Access Compliance Report

Public Rights-of-Way

Intersection ID: 30475	Main Street: PLANTERS_ROW_DR	Cross Street: WALKING_STICK_DR	Location: SE
ADA ID: AD46F82E4CD2	Ramp Type: PerpDiag	Initial Pass/Fail: Fail	Overall Compliance: No
Codes/Mitigation Info/Possible Solution			Severity Score: 10
			Field Measurements/Component Compliance

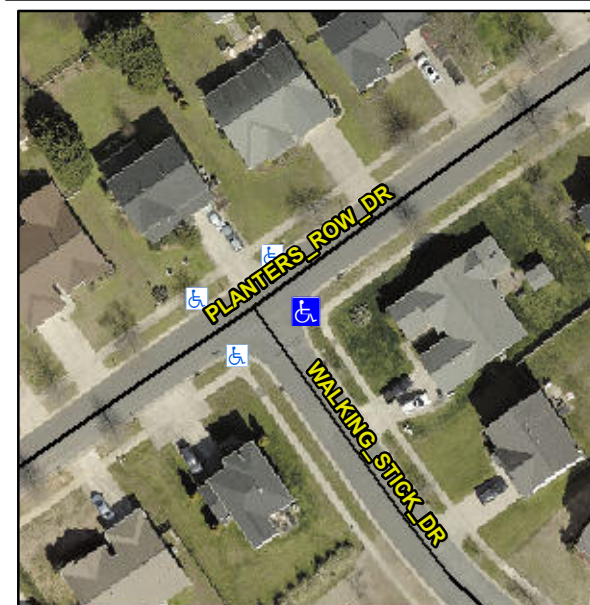
Not Found, R304.5.1, R304.5.3

Compliance	Description	Data	Compliance	Description	Data
N/A	Ramp Length (in)	83.0	Yes	Ramp Slope (%)	6.4
No	Ramp Width (in)	47.0	No	Ramp XSlope (%)	3.3
N/A	Flare Type LT	N/A	N/A	Flare Type RT	N/A
N/A	Flare Slope LT (%)	N/A	N/A	Flare Slope RT (%)	N/A
N/A	Flare Traversable LT?	N/A	N/A	Flare Traversable RT?	N/A
N/A	Landing Length (in)	N/A	N/A	DWS Provided?	N/A
N/A	Landing Width (in)	N/A	N/A	DWS Contrast?	N/A
N/A	Landing Slope (%)	N/A	N/A	DWS Length (in)	N/A
N/A	Landing X Slope (%)	N/A	N/A	DWS Full Width?	N/A
N/A	Landing Curb? (Y/N)	N/A	N/A	DWS Offset (in)	N/A
N/A	Shared Landing?	N/A			
N/A	Gutter Ponding?	N/A	N/A	Gutter Slope (%)	N/A
N/A	Gutter Lip Ht (in)	N/A	N/A	Gutter X Slope (%)	N/A
N/A	Painted X Walk1?	No	N/A	Painted X Walk2?	No
	X Walk 1 Direction	To NW		X Walk 2 Direction	To SW
N/A	X Walk 1 Width (in)	N/A	N/A	X Walk 2 Width (in)	N/A
	X Walk 1 Slope (%)	0.2		X Walk 2 Slope (%)	3.3
	X Walk 1 X Slope (%)	3.7		X Walk 2 X Slope (%)	0.7

Remove & Replace Curb Ramp With Two New Directional Ramps or Equivalent.
